Section 12A Planning Application for Proposed Amendment to the Approved Wan Chai Outline Zoning Plan No. S/H5/31 from “Comprehensive Development Area”, “Residential (Group C)”, “Open Space” and “Government, Institution or Community” zones and Area shown as “Road” to “Other Specified Uses (Residential Development with Historical Building Conserved)” and “Other Specified Uses (Elevated Walkway)” at Nos. 1, 1A, 2 and 3 Hill Side Terrace, No. 55 Ship Street [a.k.a. Nam Koo Terrace], Nos. 1 - 5 Schooner Street, No. 53 Ship Street, No. 18 Sau Wa Fong, Inland Lot No. 9048 and adjoining Government Land, Wan Chai [Application No.: Y/H5/8]

Responses to Comments Table

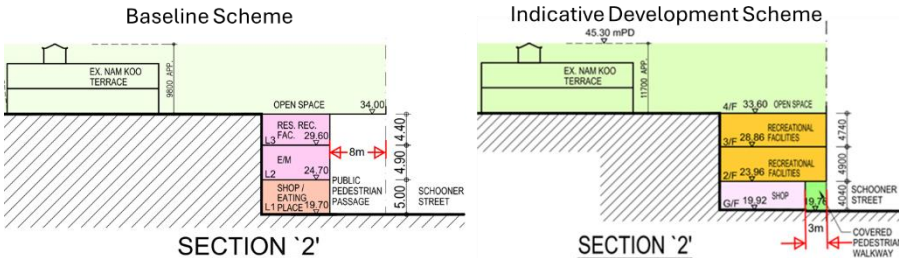
| Comments/ Suggestions   | Applicant’s Responses  |
|---|--|
| <p>4. Measures to reduce the potential impacts of the proposed development on Nam Koo Terrace in terms of BH, massing and scale should be adopted. Reference could be made to Section 6.2 (6) of the Urban Design Guidelines (Chapter 11) of the HKPSG.</p> | <p>have been incorporated in the IDS to reduce the apparent visual mass and to enhance visual permeability to avoid a sore thumb development. These include (i) an at-grade setback at Schooner Street, (ii) provision of a void underneath the residential tower, (iii) sufficient building separation with landscaped buffer between the residential tower and NKT; and (iv) a distinctive façade treatment to soften the building edge and add visual amenity to the area. In addition, the IDS has provided ample landscaped open spaces open to public at both at-grade and podium levels to create orientation and a sense of place.</p> <p>In consideration of the BH, the IDS is predominantly surrounded by a belt of high-rise developments subject to a BH restriction of 120mPD along Kennedy Road and abuts the super-high-rise Hopewell Centre II (210mPD), ensuring an appropriate transition to the Sau Wa Fong area of medium-rise residential developments. In this regard, the proposed 120mPD at the Rezoning Site is considered generally in line with the BH profile in the surrounding area.</p> <p>The potential for further reduction of the building bulk has been fully considered, and any numerical gains that can be achieved cannot outweigh the visual and urban design benefits of the current IDS. Tower setback from the site boundary fronting Schooner Street is not preferred, as this would result in a more sore-thumb slenderer “pencil-like” development and no further benefit in terms of already “acceptable” visual impact. Nonetheless, further enhancement and refinement of the IDS in terms of façade treatment and landscaped buffer are subject to the detailed design stage.</p> <p>The IDS has fully considered the potential impacts of the Proposed Residential Development on NKT in terms of BH, massing and scale with a number of design features proposed, including:</p> <ol style="list-style-type: none"> <li>(1) A building-free design is adopted in front of NKT to create a spacious forecourt with a sophisticated landscape proposal responding to the historical setting and character of NKT as a mansion before being vacated.</li> <li>(2) Create a landscaped podium of the new residential tower at the same level with NKT allows the residential tower to integrate more coherently with the scale and the character of NKT. As well as to provide ease of access for users within the Open Space area.</li> <li>(3) Views to and from NKT are also preserved and opened up to enhance visibility of the preserved historical building.</li> </ol> |
